ADDENDUM 3

BID No. & Title: **02-018 SETTLERS HILLS CROSS COUNTRY COURSE**

Notes for Addendum 3

5 START VIEWING AREA, TYPICAL SECTION
SCALE: N.T.S.

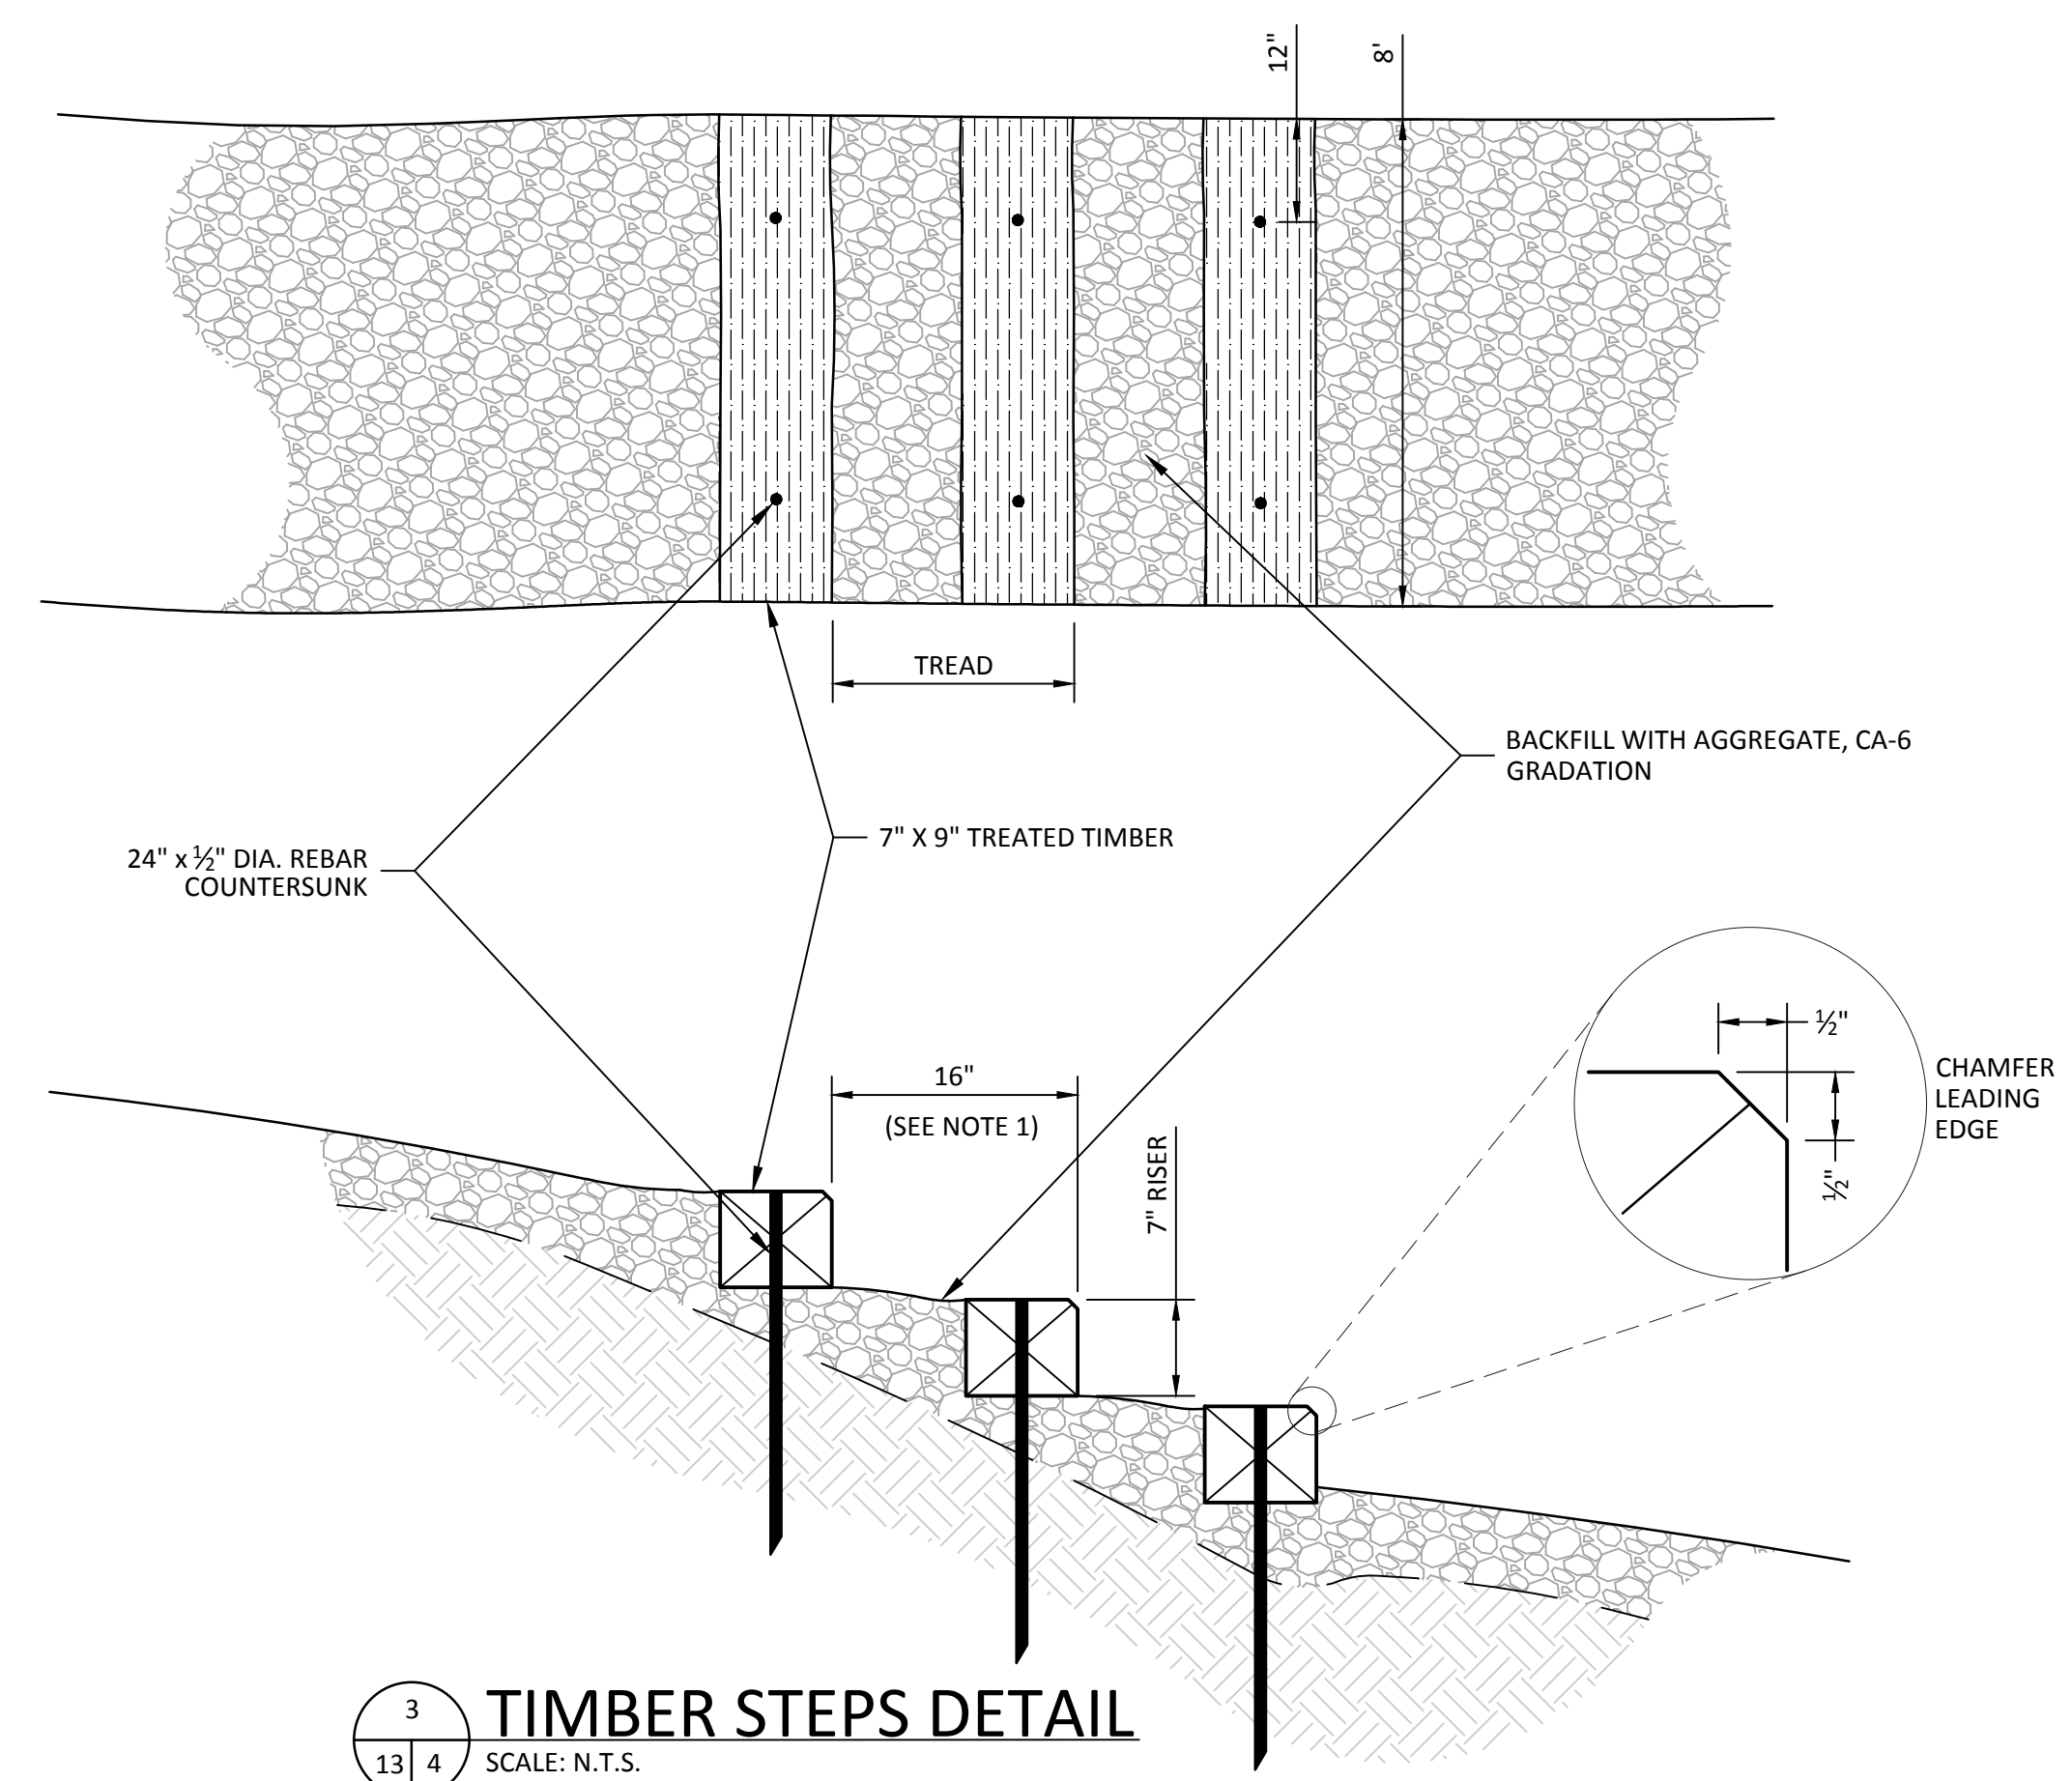
Sheet No.	Sheet Name	Revision Description
4	Typical Section	The following note has been added to Detail 5: "Provide Smooth Surface that Approximately Follows Existing Slope, Min. 1%".
18	Outlet Control Detail	Outfall pipe at DS 20: The 10 feet of 36" pipe from the inlet to the manhole has been revised to a 24" pipe, to match other details.
26	Cross Section	The overlapping text on the Station 4+00 cross section has been removed.
